Our Reference: NP24.219
TCC Reference: MCU25/0031 & RAL25/0033
MM.

Response to Information Request

**Development Application for Material Change of Use – Alterations to Existing Landscape Supplies and Garden Centres and New Food and Drink Outlet (Drive Through Coffee Shop) combined with Reconfiguring a Lot – 1 Lot into 2 Lots and Access Easement
13 Lynam Road, Bohle Plains and formally identified as Lot 8 on SP191768**

1 PROPOSED SITE PLAN - PART
1 : 250 AT A1 SHEET SIZE

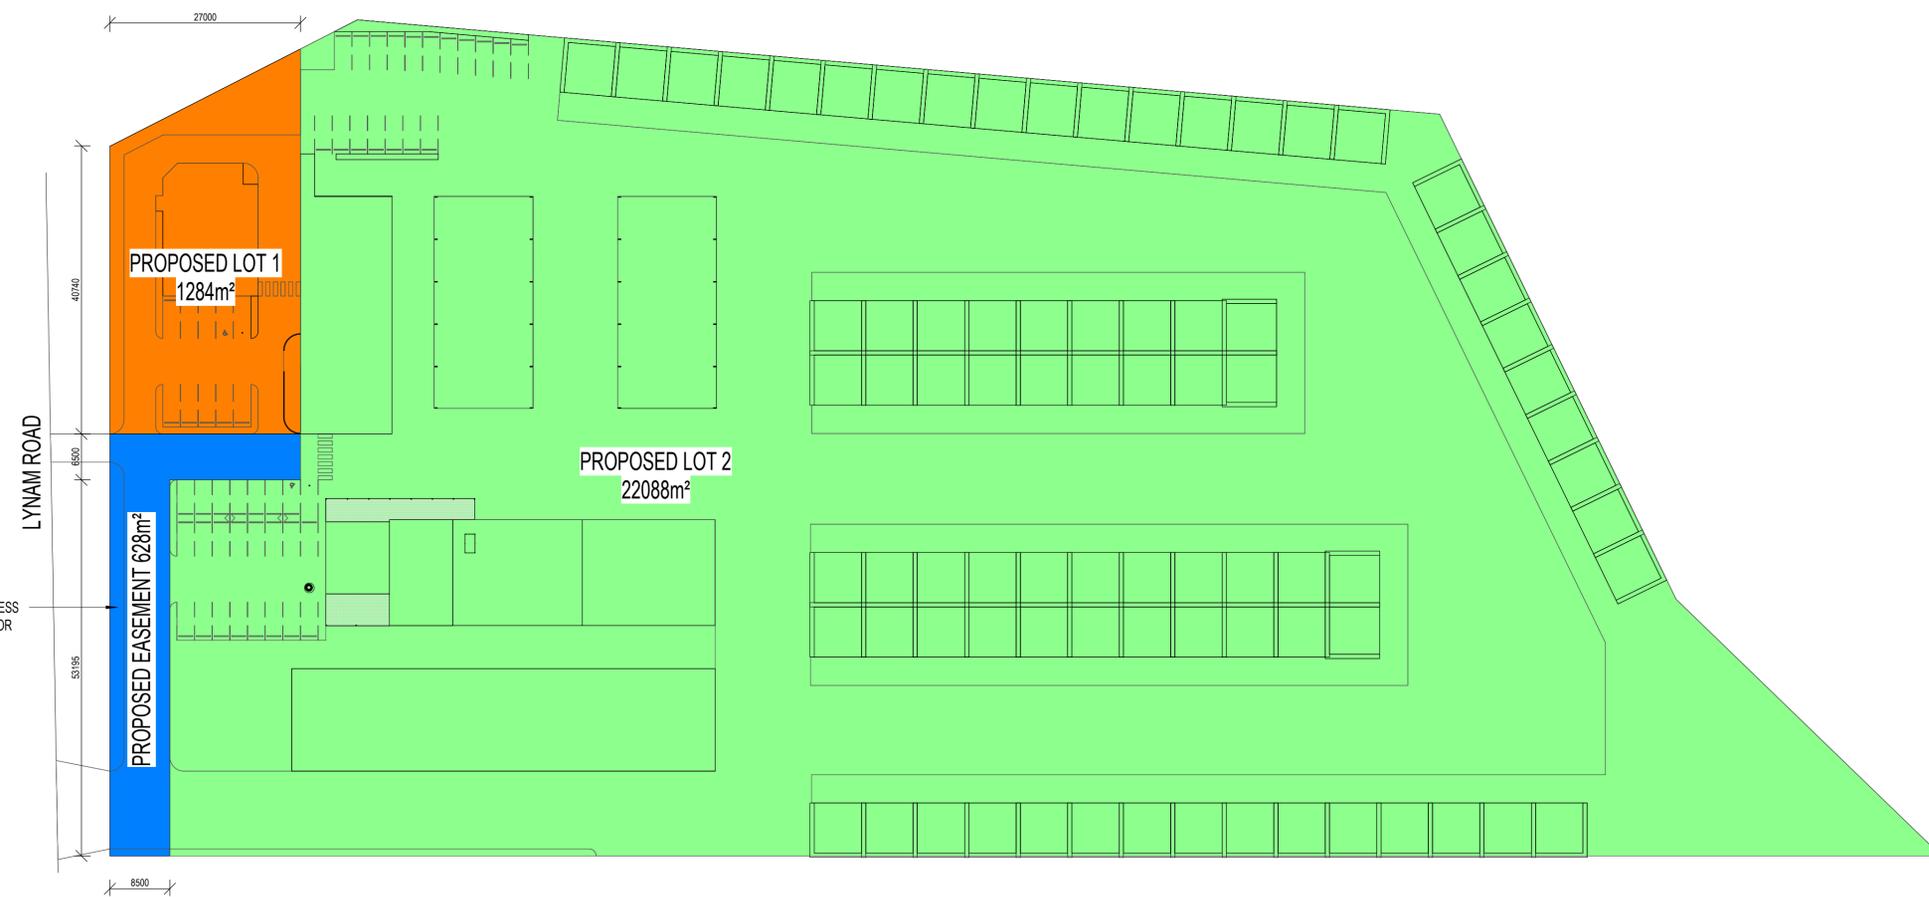
This request item requires the applicant to provide amended landscape plans, detailing:

- a) *Additional shade trees for Stage 2 car park (1 tree per 3 car parks in single row parking). Shade tree plantings to have a 1.2m wide garden bed width to allow for mature growth.*
- b) *Street trees to be provided along Lynam Road frontage and Hervey Range Road frontage. Suitable species must be considered in terms of proximity to power lines, road setbacks, and other infrastructure within the road reserve.*

In response to this item, development plans have been amended to include the requested landscape features, specifically:

- The provision of additional shade trees to Stage 2 car parking in accordance with SC6.4.12.5(6)(c) of Council's Development Manual Planning Scheme Policy, being:
 - (i) in single sided, angle or parallel bays - 1 tree per 3 car parks; and
 - (ii) in double sided – 1 tree per 6 car parks.
- The provision of street trees along Lynam Road frontage and Hervey Range Road Frontage in accordance with the Planning Scheme.
